## Converting timing belt from 152 teeth to 153 teeth

**Manufacturer:** Audi, Volkswagen

**Model:** (Audi) A4, A6, Cabriolet  
(VW) Passat

Issued 04.2009  
**INA 0025**

### 530 0359 10

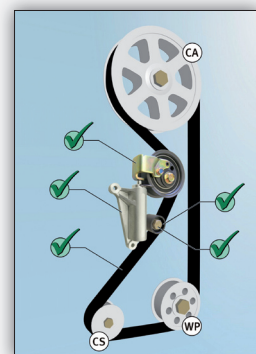
- For vehicles yet to be converted
- Optional for those already converted Vehicles

Tensioner pulley	531 0499 20
Hydraulic Damper	533 0032 20
Deflecting pulley	532 0161 10
Timing belt	536 0250 10
Bolt	M8 x 32 mm
